2130-06-20269
March 15, 2006

Oyster Creek Generating Station
Facility Operating License No. DPR-16
NRC Docket No. 50219

Subject: Clarifications to Responses to NRC Request for Additional Information related to Severe Accident Management Alternatives (SAMA) for Oyster Creek Generating Station (TAC No. MC7625)

Clarifications Associated with SAMA RAI Responses

Figure 1c-1 Review Process for Oyster Creek PRA Model

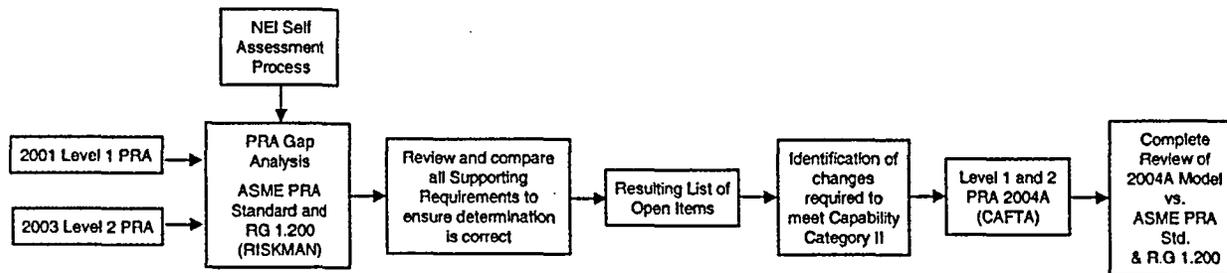
Was the 2004A analysis subjected to a complete self assessment or was the focus of the re-review limited to those gaps found in the 2001 PRA? Of concern is the completeness/applicability self-assessment of the 2001 PRA relative to the 2004A model considering the extensive changes from the 2001 model to the 2004 model not the least of which is the change from support state (RISKMAN) modeling to linked fault tree (CAFTA) modeling.

The Oyster Creek 2004A model, documentation, and results were subjected to a complete self assessment to ensure that they reflected the insights from the RISKMAN model and the model changes made during the 2004A model preparation.

AmerGen performed the analysis of the "gaps" of the 2001 Level 1 PRA and the 2003 Level 2 / LERF PRA relative to the ASME PRA Standard [1] and the RG 1.200 [2] changes by direct comparison between the Standards and the PRA. The NEI self-assessment process was used as a second check, but was not a primary input. It was used to ensure that no deficiencies that had previously been pointed out continued to persist. The assessment was performed on the model and documentation compared with the two documents, Ref. [1] and [2].

The 2004A model was targeted to comply with the ASME PRA Standard. The areas of compliance in the 2001 PRA model were retained and updated using a consistent methodology to meet Ref. [1] and [2].

Following development of the 2004A model, it was then completely re-assessed using the Ref. [1] and [2].

Figure 1c-1 summarizes this process.
